***Ducted Systems
Technical Services
Service Letter***

Letter: **YS-002-2021**

Subject: **Blocked suction process tube / Suction access port on Heat Pumps**

Product: THE, YEE, TE4B, REP14L, YHE, TH4B, RHP14L, YHG, CH6B, TH6B, RHP16L, YZT, HC19B, and HL19B

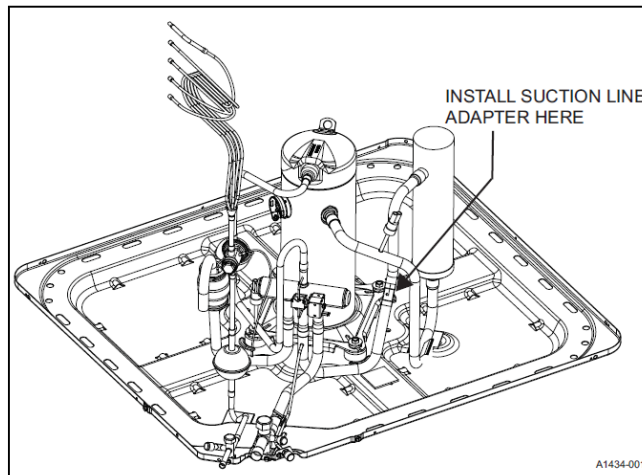
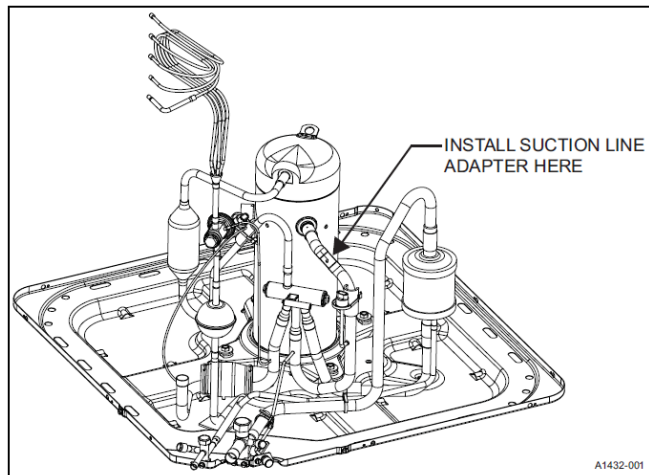
Our internal investigation revealed that the suction process tube was being brazed shut during unit build. It was determined the cause of the error was an improperly created hole in the suction line tubing where the process tube is inserted prior to brazing. Specifically, the hole appears to be pressed instead of drilled which created a "pool" as shown in the image below. During process tube brazing, on some units, the process tube would fill with brazing alloy completely sealing it off from the refrigeration circuit. On units brought back to the factory for investigation when we removed the suction process tube the suction line itself remained sealed with a "slug" of brazing alloy. See images below of sealed suction line and slug of brazing alloy removed from the suction line.

Since the currently installed suction process tube cannot be safely removed and re-inserted at the same location due to the excessive amount of brazing alloy, we have developed a kit that contains 3 different sizes of a pre-drilled copper couplings as shown to the right, replacement suction process tube, bi-flow liquid line filter drier, cable ties, and installation instructions. The field repair kit is part number S1-37347211001. The blocked suction process tube will remain installed in the unit but rolled back behind the unit block off panel and secured with a cable tie. The copper coupling and replacement suction process tube will be installed in a different location between the reversing valve and compressor. Specific locations are called out in the kit installation instructions and a few examples of the copper coupling locations are shown below.
